Access Compliance Report

Public Rights-of-Way

Intersection ID: 52150	Main Street: ENGLAND_ST	Cross Street: ARROWOOD_STATION_DR	Location: NE
ADA ID: FCDB7B7B85F8	Ramp Type: PerpDiag	Initial Pass/Fail: Fail	Overall Compliance: No
Codes/Mitigation Info/Possible Solution		Field Measurements/Component Compliance	
Severity Score: 12.5

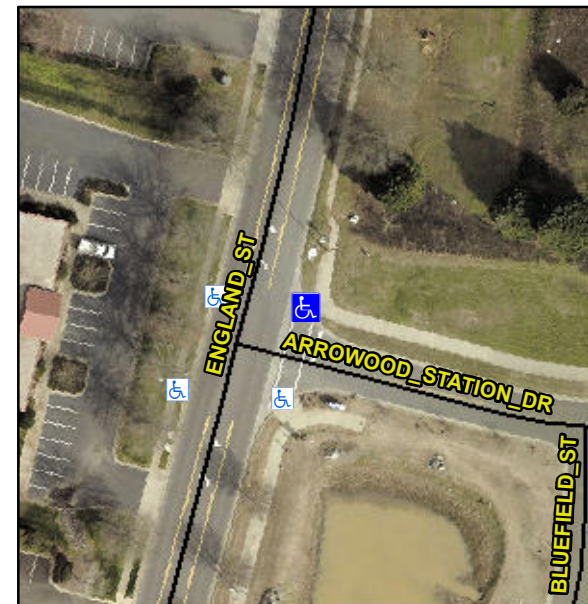
Not Found, R304.2.2

Remove & Replace Curb Ramp With Two New Directional Ramps or Equivalent.
